SUPPLEMENTAL ENVIRONMENTAL IMPACT STATEMENT for the Alpine Satellite Development Plan for the Proposed Greater Mooses Tooth One Development Project

Volume 3: Chapter 8 Public Comments and BLM Responses

October 2014

Figure 3.3-7

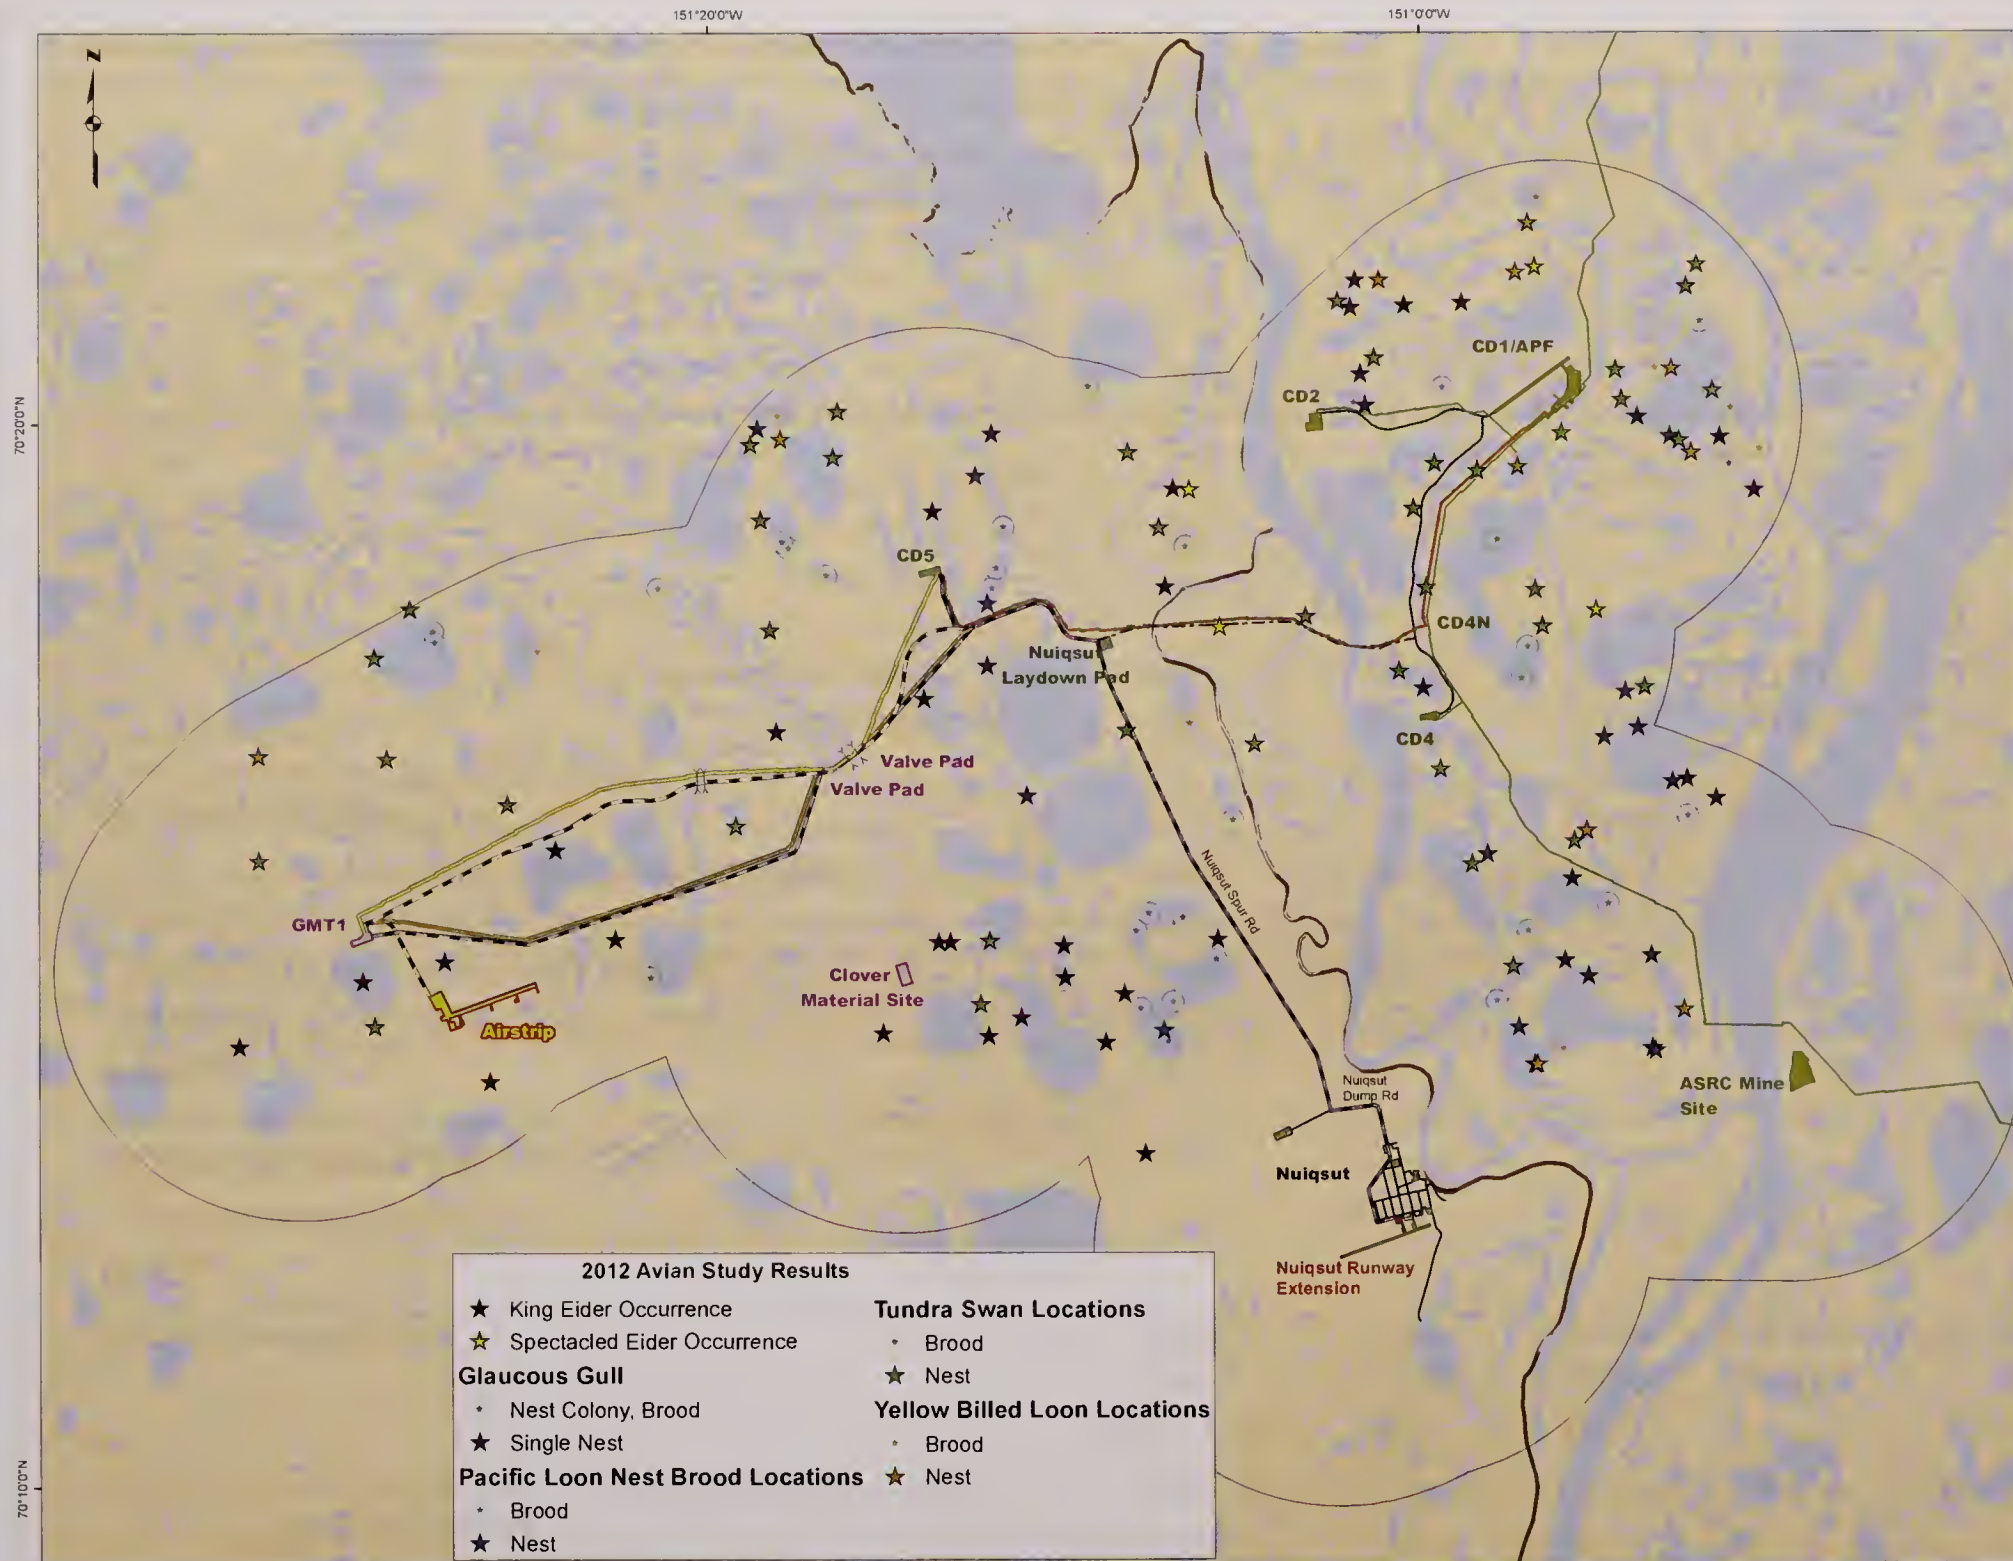
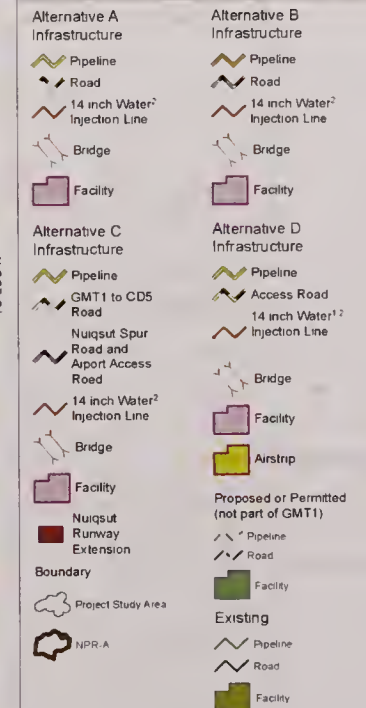
USACE		Birds 3.3.3	90	1 and 2		[T06-057] Recommend that these paragraphs be inserted as the beginning paragraphs under Birds 3.3.3 on Page 87
USACE		Birds 3.3.3	476	Figure 3.3-7		[T06-058] The color of the stars for king eider occurrence, glaucous gull nest, and pacific loon nest are very similar and hard to differentiate on the map. Recommend changing color or shapes.
USACE		Table 3.3-4.	90			[T06-059] Were bird surveys conducted within the 2011-2012 Development Subarea? This is unclear in the SEIS and should be better clarified.
USACE		Gulls 3.3.3.1	92	4	1 and 2	[T06-060] The first two sentences are confusing since Figure 3.3-7 documents loon and gull nests occurrence within the study area. If surveys for gulls were conducted in the Development Subarea, then this should be clearly specified in this paragraph.
USACE		Waterfowl 3.3.3.4	94	5	2	[T06-061] Information should be included to state why these particular waterfowl species were selected.

The reference to Figure 3.3-7 has been removed from Section 3.3.5. The nature of a supplemental document is to communicate new data not presented previously. This is what the Final SEIS text does; however, it also provides data from previous years within the text for comparison. BLM does not agree that an explanation should be included that the primary focus of a supplemental EIS is to communicate new data. Explanation of this concept is adequately provided in Section 1.4: "This SEIS has been developed to supplement the 2004 ASDP EIS, focusing on the changes that have occurred in the interim to the project design, the affected environment, and the regulatory framework in order to provide sufficient information for BLM and other federal agencies to fulfill their NEPA responsibilities."

Figure 2: Species of concern within project area (Source: Audubon Alaska)

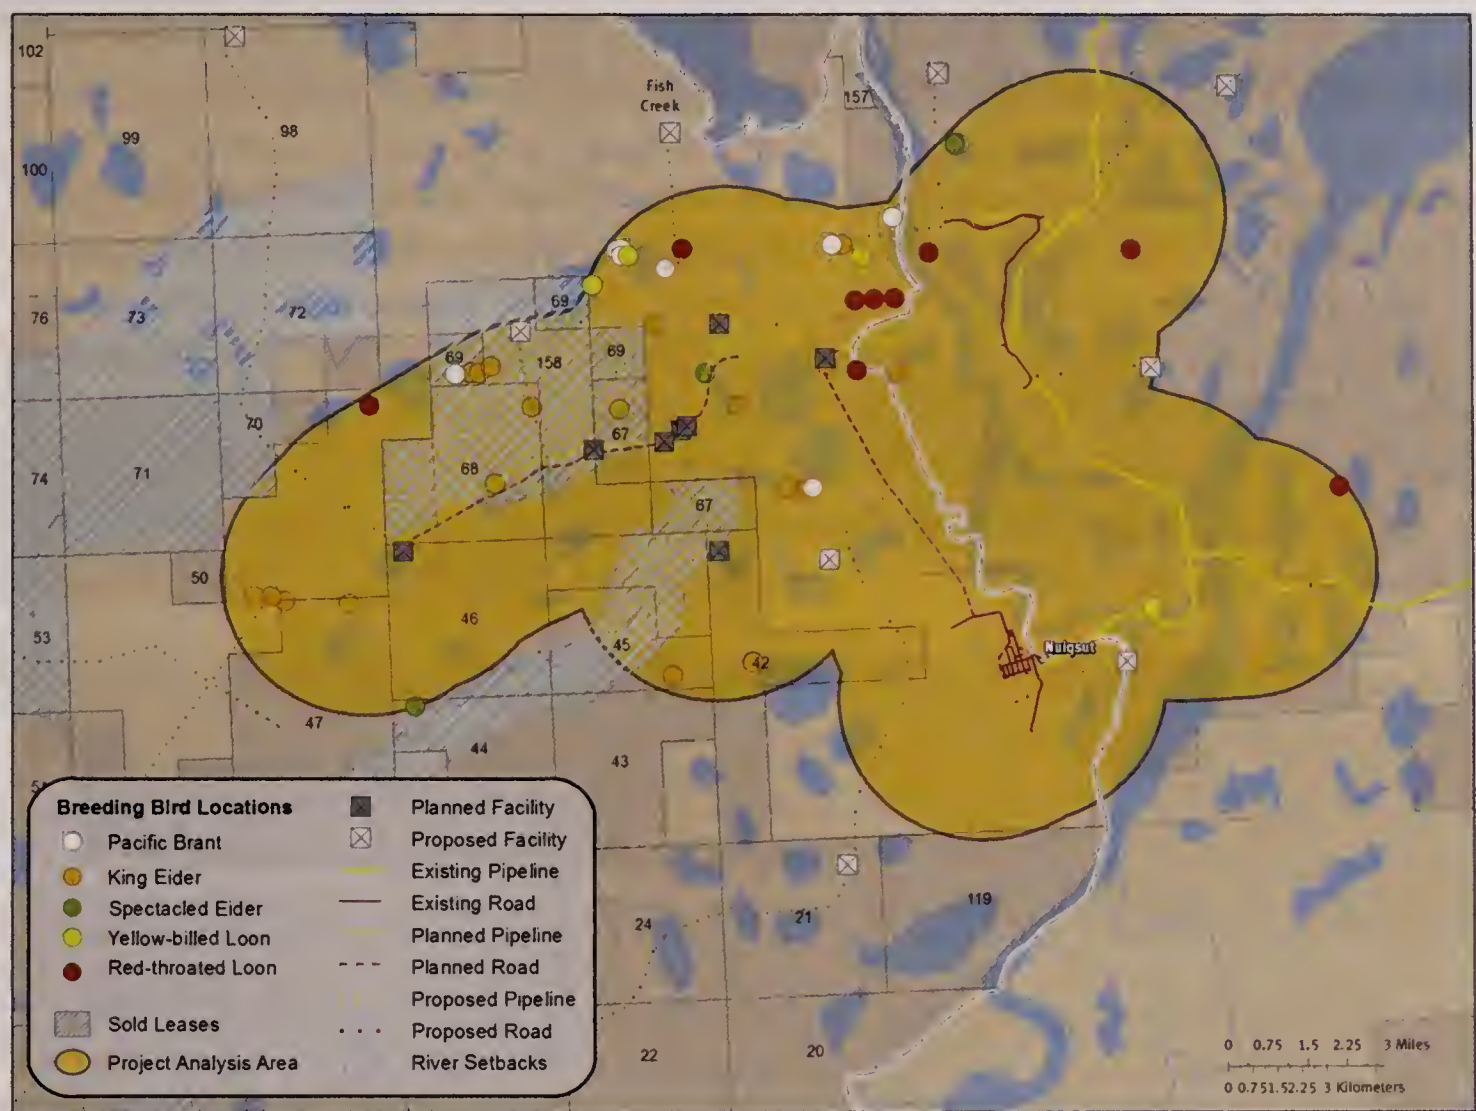
As shown in Figure 2, there are 80 locations within the project analysis area for five species of concern, mapped based on the Alaska WatchList of vulnerable and declining populations. The species and number of locations are: Spectacled Eider (16), Yellow-billed Loon (4), King Eider (30), Pacific Brant (18), and Red-throated Loon (12). Within the larger cumulative effects area, 623 locations for the five WatchList species are: Spectacled Eider (47), Yellow-billed Loon (21), King Eider (349), Pacific Brant (142), and Red-throated Loon (64). It is not known from these data whether the breeding sites were used multiple times over the ten-year period. For planning purposes, the location of used habitat in proximity to infrastructure should be considered during project implementation, and direct and indirect impacts should be avoided.

Figure 1. **[16-012]** Subsistence caribou harvest areas for Nuiqsut from Braem et al. 2011 that could be used to quantify changes in simulated caribou abundance and distribution.

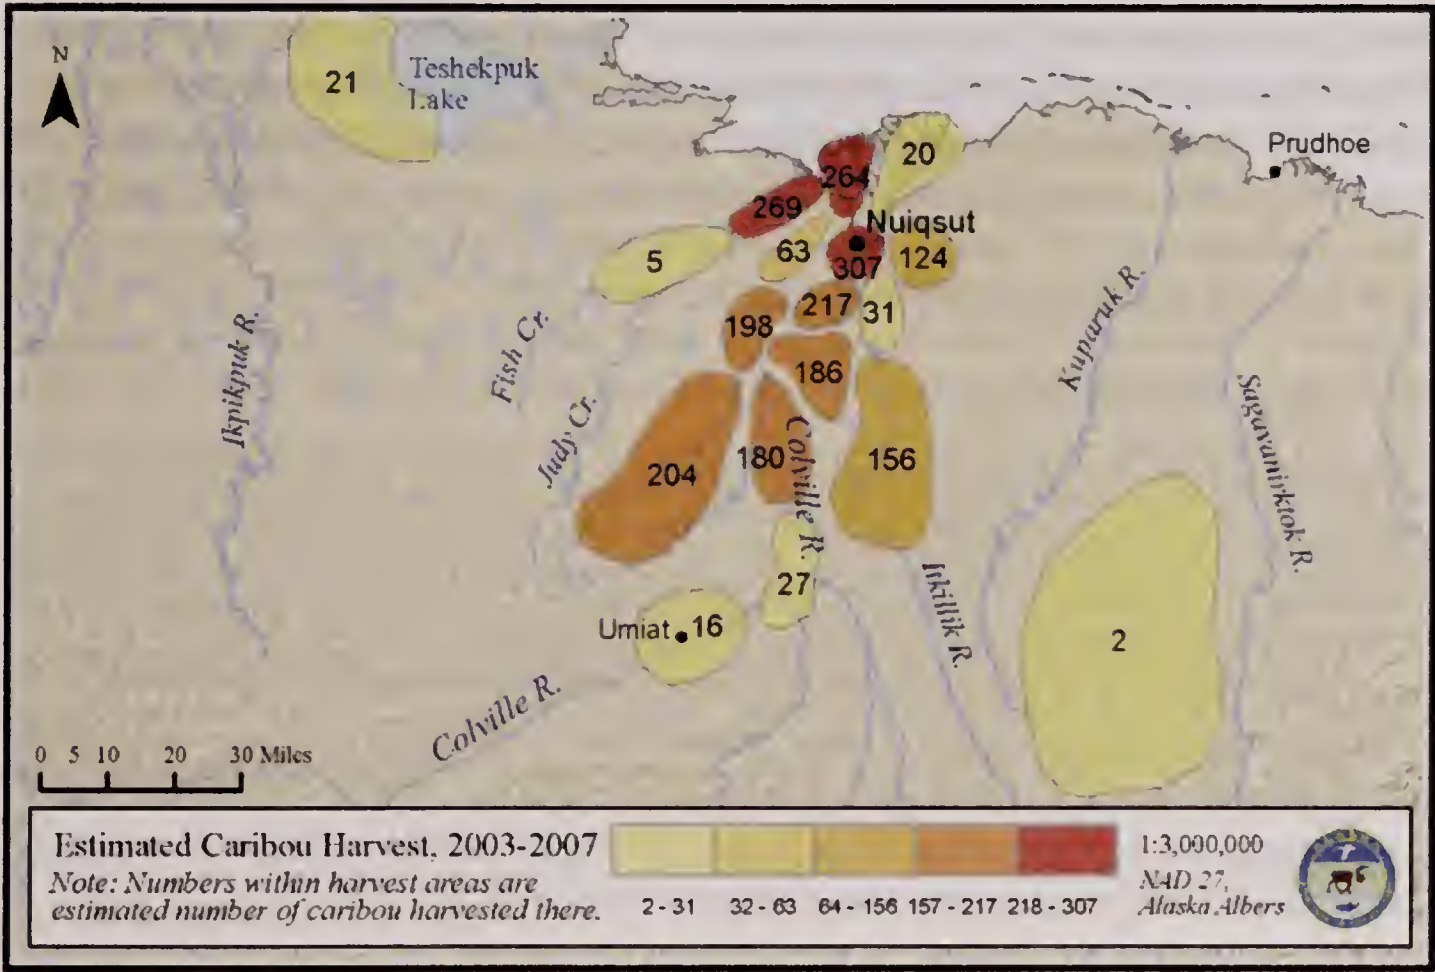
[16-011] To determine how hunter access to caribou might be altered, an attempt should be made to understand how changes in caribou use of the area due to the road changes the distribution of caribou in subsistence hunting areas, such as those depicted by in studies (Braund et al. 2013; Braem et al. 2011; Figure 1). Comparison of no development (Alternative E) vs. development scenarios (Alternatives A-D and any modifications for FSEIS) will allow for a comparison of how each alternative might affect hunter cost and probability for success.

Figure: Caribou Harvest Locations Years 1-4 in Alternative A

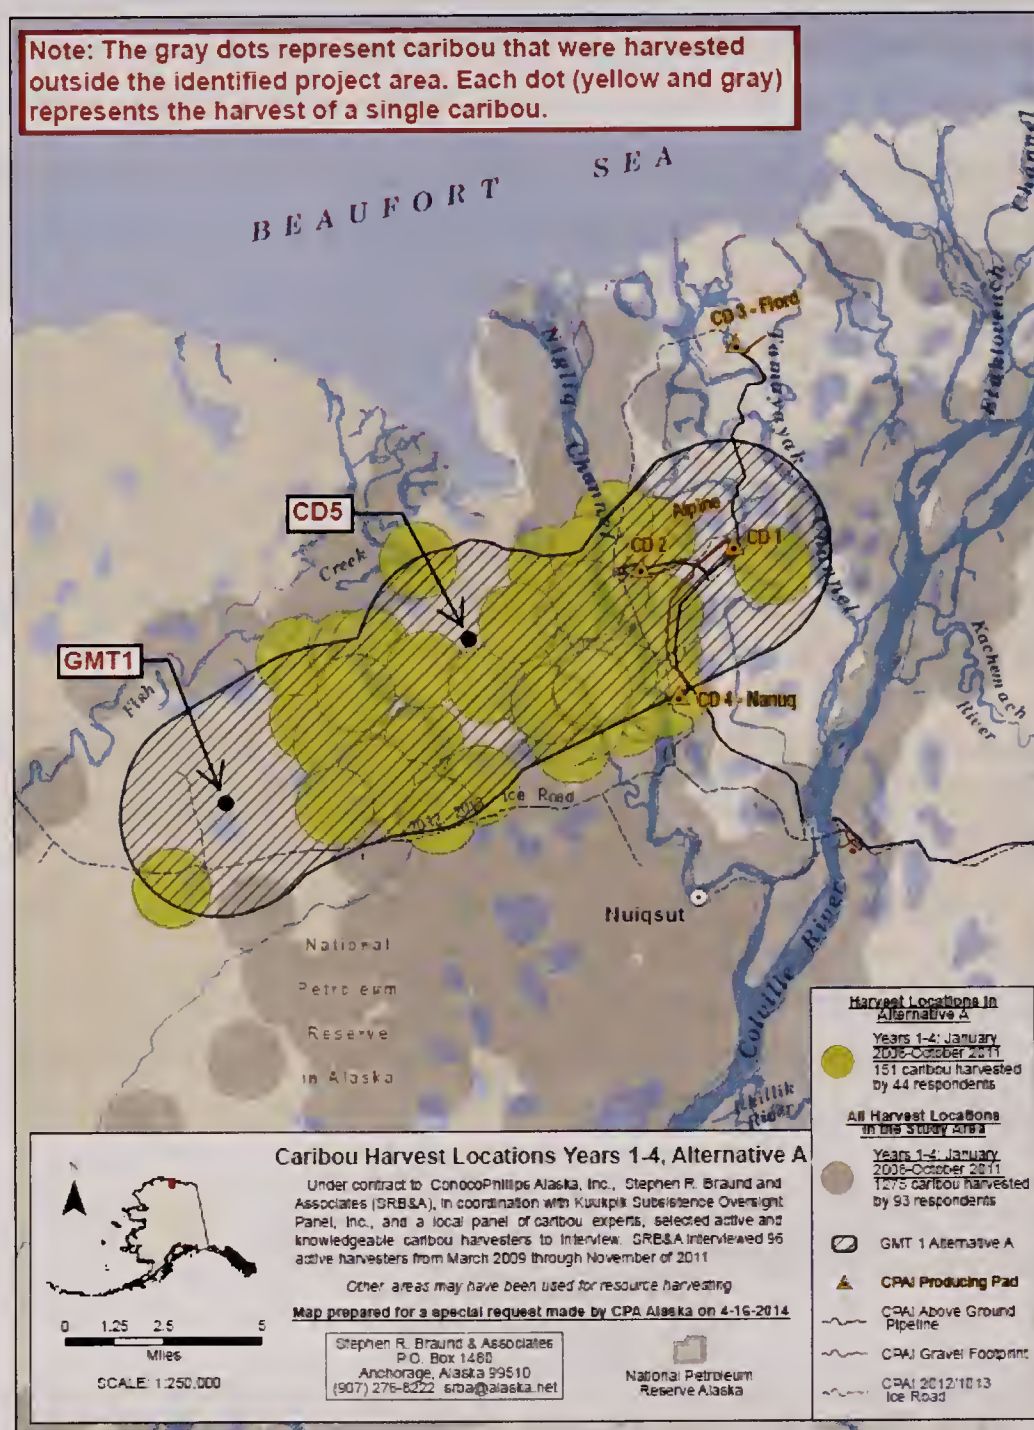
[18-067] This data indicates that 26% of caribou harvested from Nuiqsut are harvested in the project study area. Conversely, 74% percent of the caribou are harvested elsewhere. Looking at ConocoPhillips’ proposed project, only 12% of caribou are harvested in the area associated with Alternative A. No project alternative has a lesser impact on harvest areas. Of that 12 percent, the vast majority of caribou harvested are taken along the rivers that are in the project study area only because they would be crossed at one location by a road and pipeline, which would not exclude the continued harvesting of caribou on those areas. [See Figure below “Caribou Harvest Locations Years 1-4 Alternative A.”]

[18-068] Moreover, the harvest data also shows zero harvest of caribou within over a mile of the proposed GMT1 drill site. These data demonstrate that the particular area that will involve the most project activity and, accordingly, which harbors the most potential to cause avoidance by subsistence users, is not an important area for harvesting caribou [Attached Figures]. The DSEIS does not recognize this significant information.

Figure 1: Proposed GMT1 Pipeline Design Height

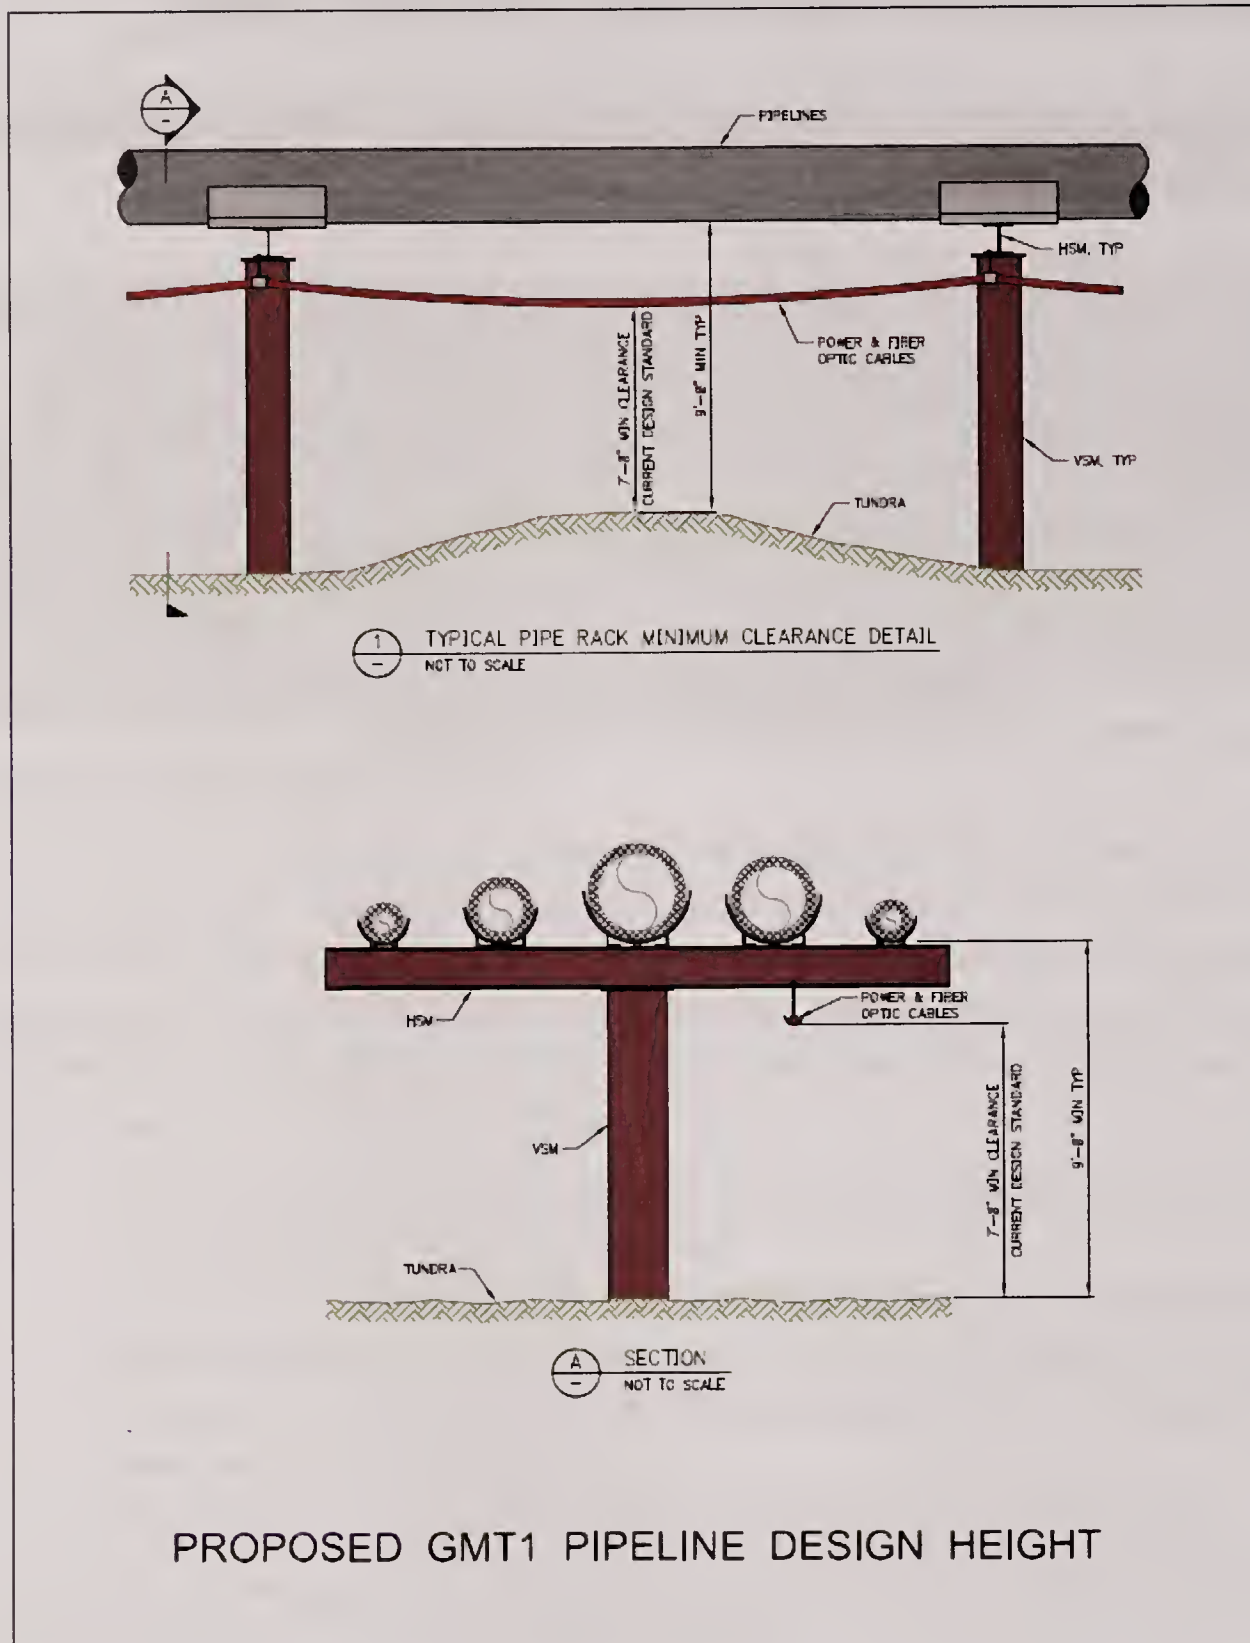
[18-128] Pipelines and roads are designed to allow free movement of caribou and the safe, unimpeded passage of the public while participating in subsistence activities. Above-ground pipelines are elevated a minimum of 7 ft as measured from the ground to the messenger cable installed on the pipeline VSMs. In most instances, this relates to a minimum distance of 9 ft from the ground to the bottom of the pipeline (Figure 1). Depending on the terrain and the hydraulic design, this actual height can be much greater. For example, the height from the ground to the bottom of the pipeline for the CD5 pipeline ranges from 10 – 24 feet (at Lake M9525) (Figure 2). A minimum distance of 500 ft between pipelines and roads will be maintained, where feasible, as studies have shown that this facilitates caribou movement.
